## NIOWAVE, INC

Attn: Mr. Kevin Null  
Subj: Requested Amendment of NRC License Number 21-35144-02

Subj: Requested Amendment of NRC License Number 21-35144-02

Figure 1. A gamma spectrum from a natural uranium sample (background is subtracted).

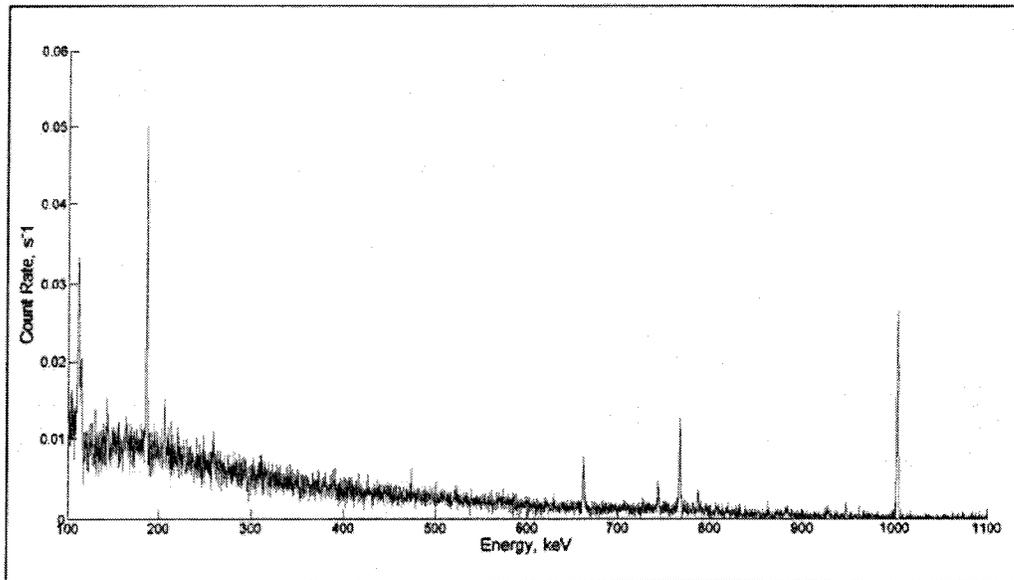
2. Submit procedures that will be implemented to verify that what you receive does not exceed possession limits, or the percent enrichment that you commit to stay within.

The ratio of activities of U-235 and U-235 was found using Eq. 3. from a gamma spectrum obtained with the HPGe detector setup (see Figure 2).

Using the above method the enrichment of the sample was found to be  $0.76 \pm 0.17\%$  which is consistent with the expected enrichment of 0.72% of natural uranium.
